SITE DEVELOPMENT PLANS

33 TOWNHOUSE UNITS

1525 & 1601 & 1603 & 1605 EAST 86TH STREET & 1604 & 1606 EAST 87TH STREET
BLOOMINGTON, MINNESOTA

REVISIONS	
04.28.26	CITY COMMENTS
05.12.26	REVISIONS
06.01.26	PLANS FINALIZED

PROJECT: 91040
 SHEET NO.
 C2 of C16

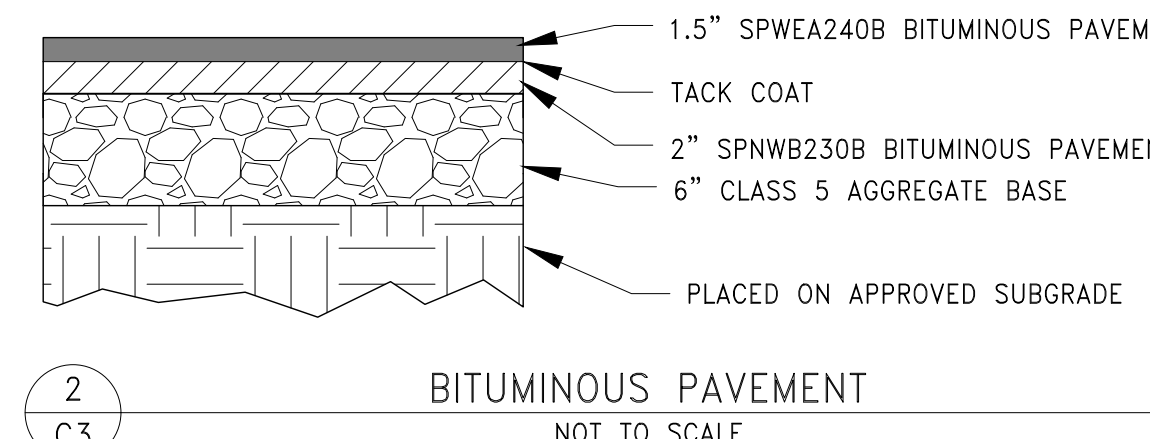
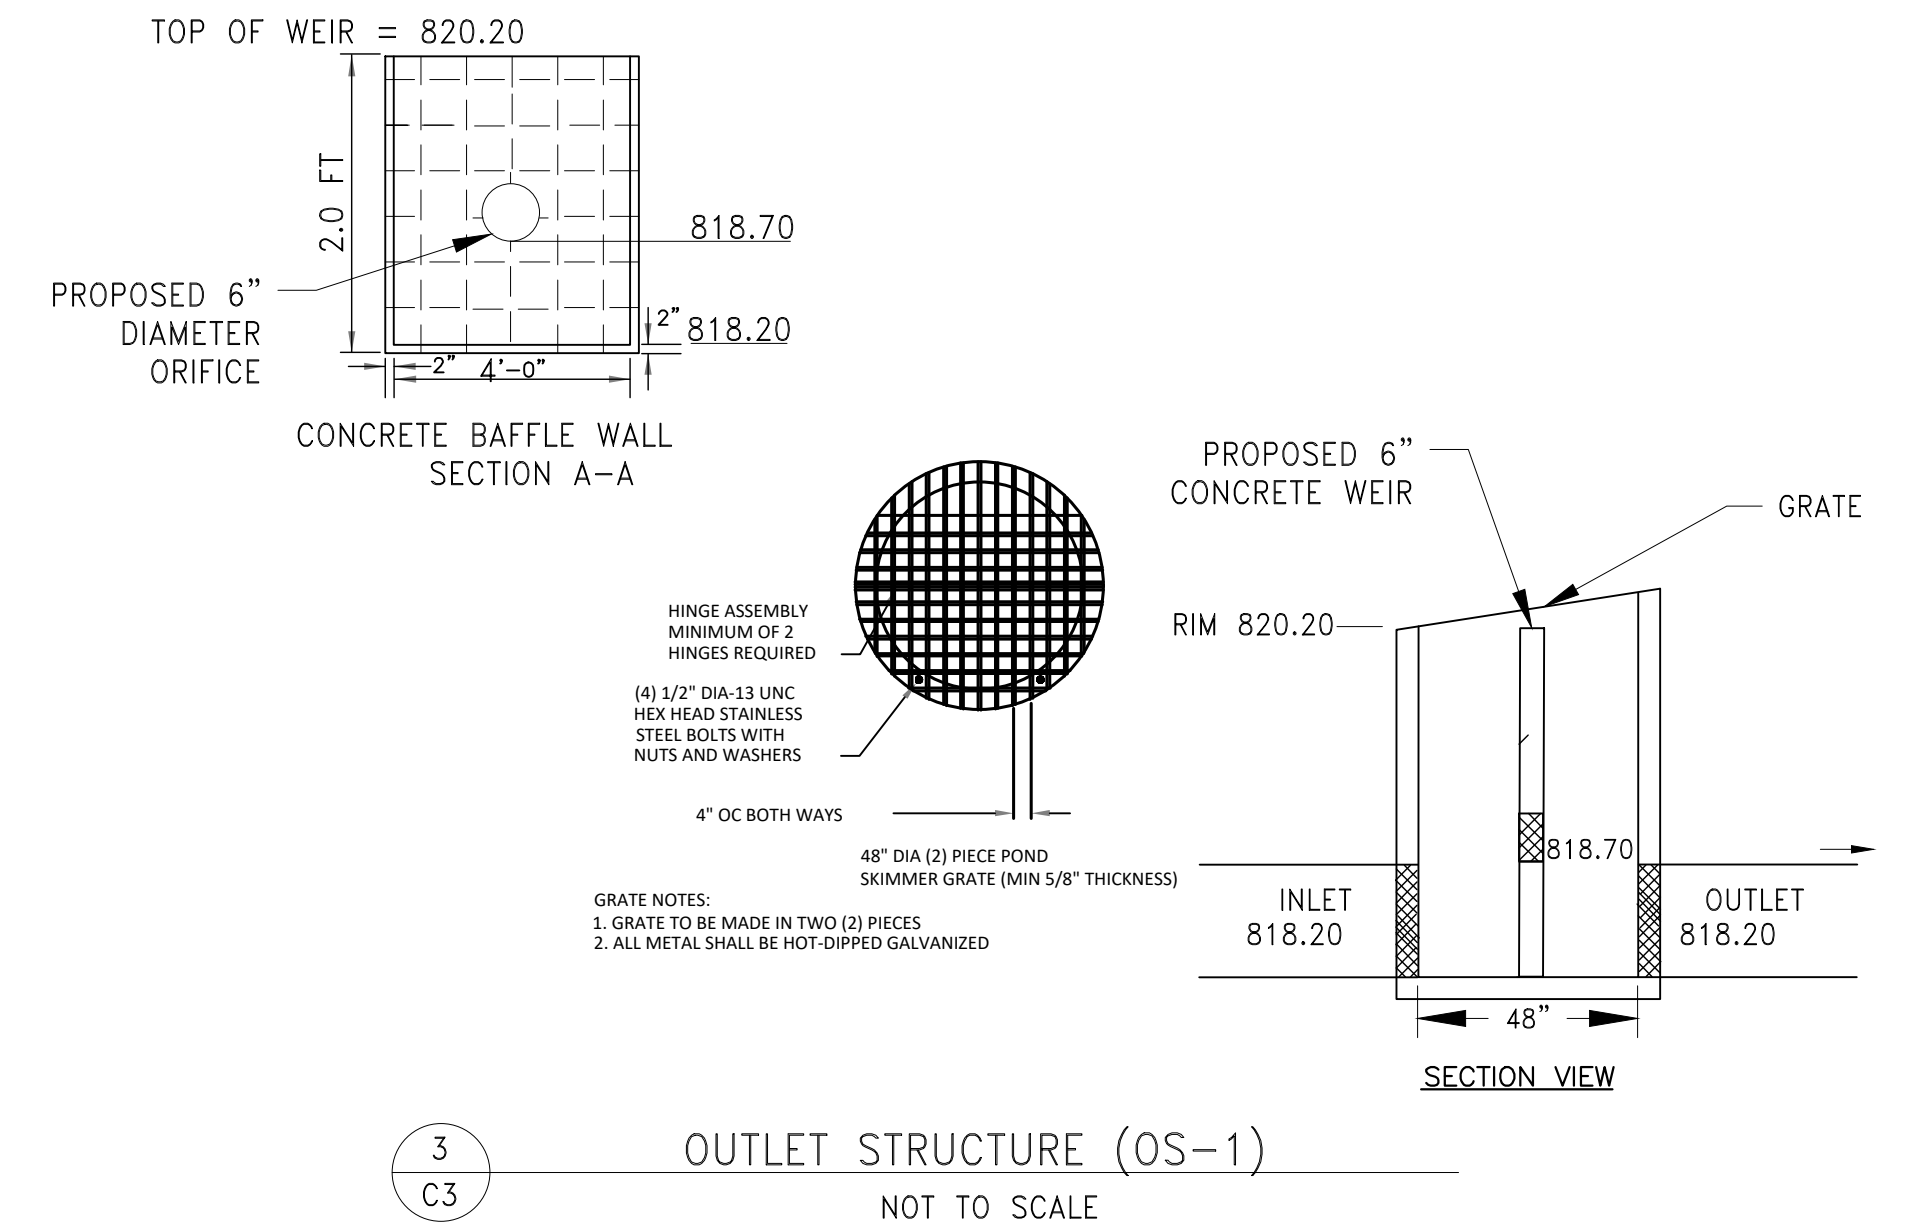
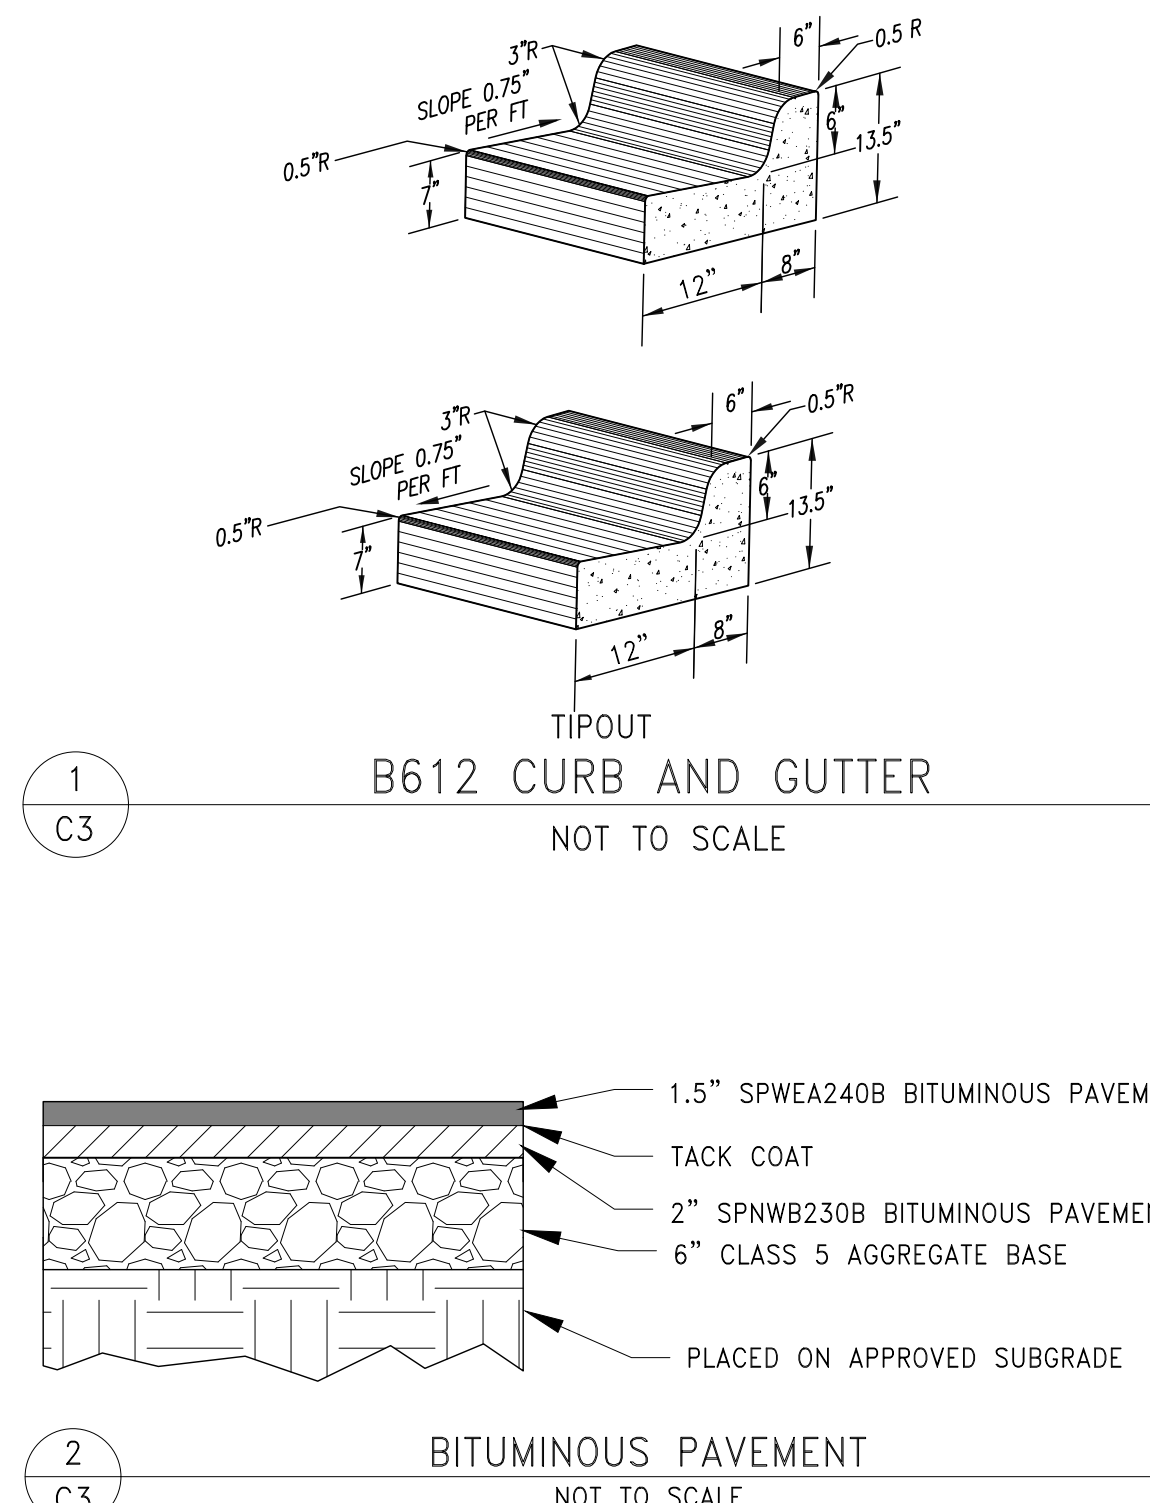
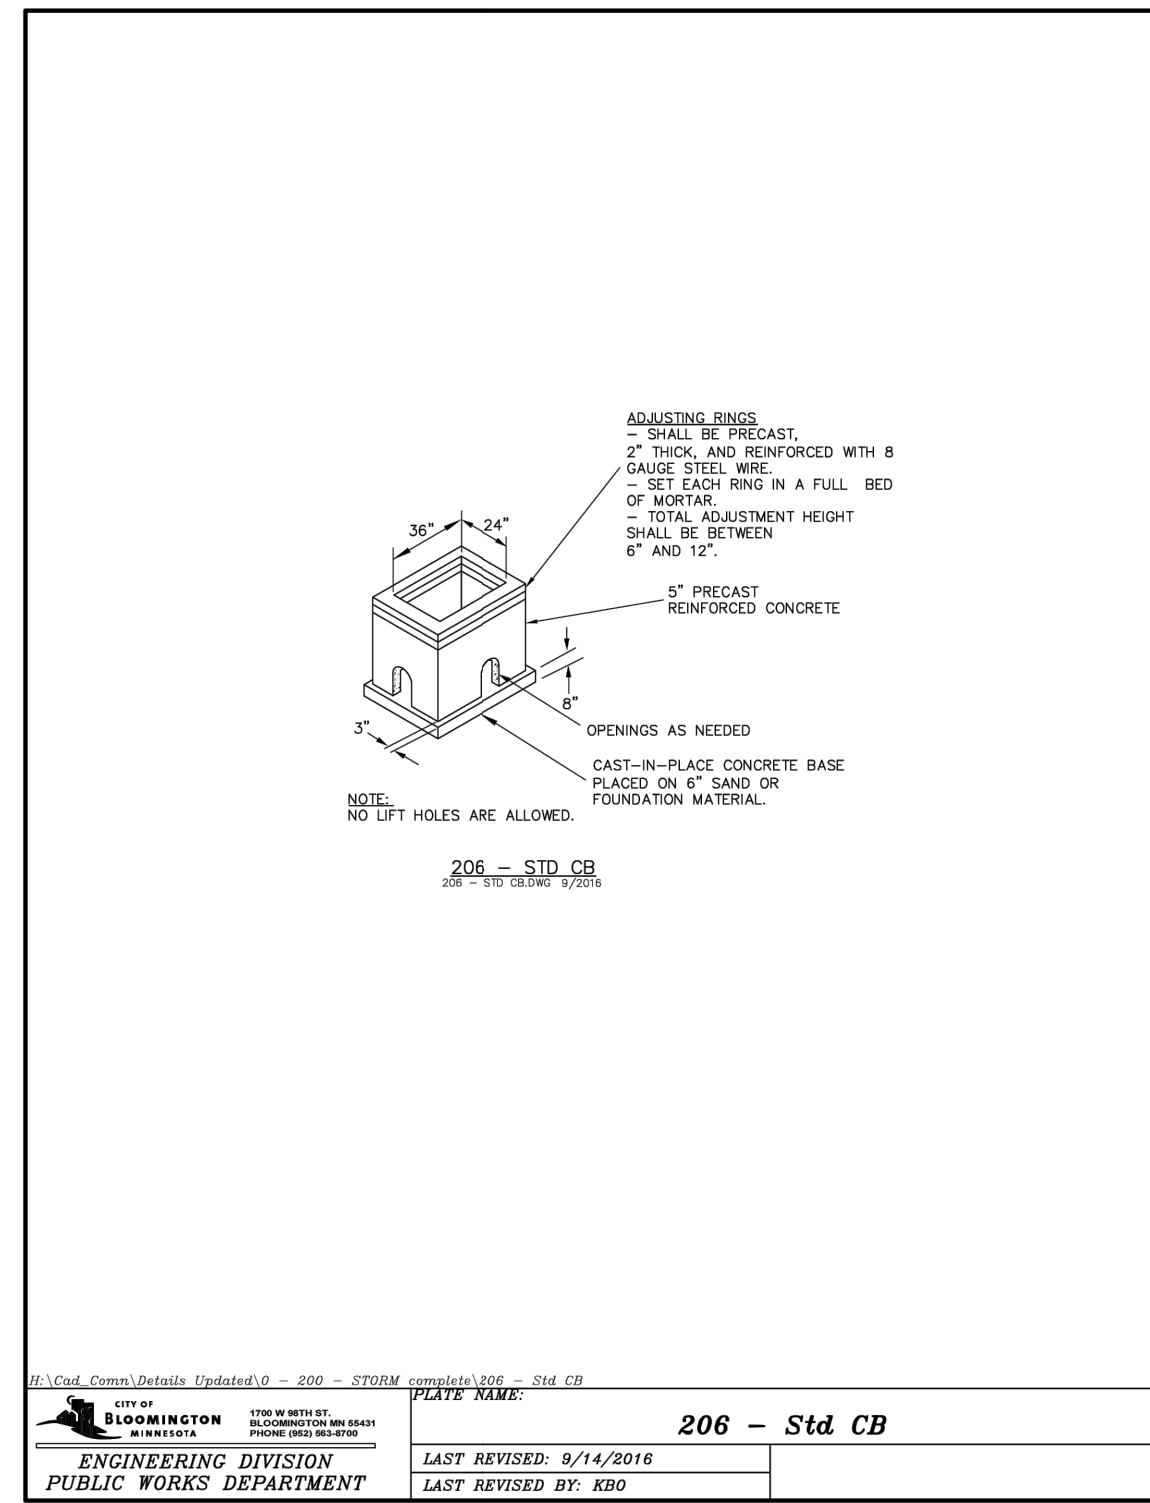
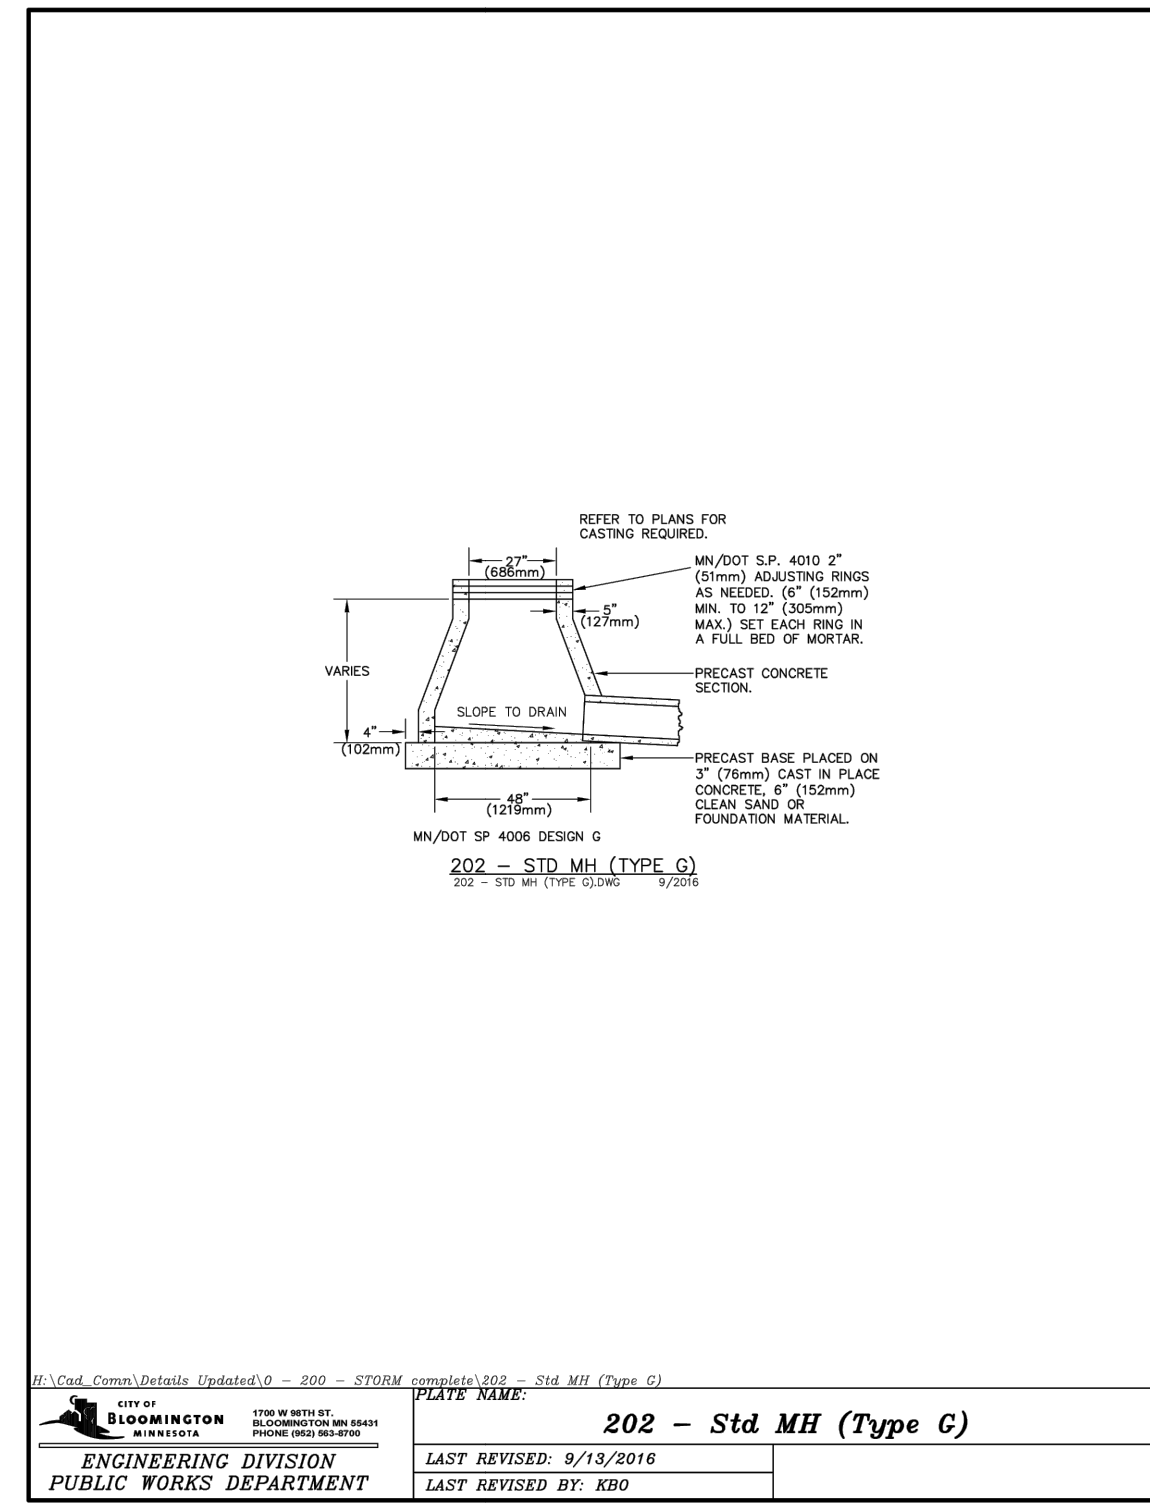
Include Std B618 C&G and Sidewalk details

Utilities review: Missing water/sanitary details (services, hydrant, etc.)
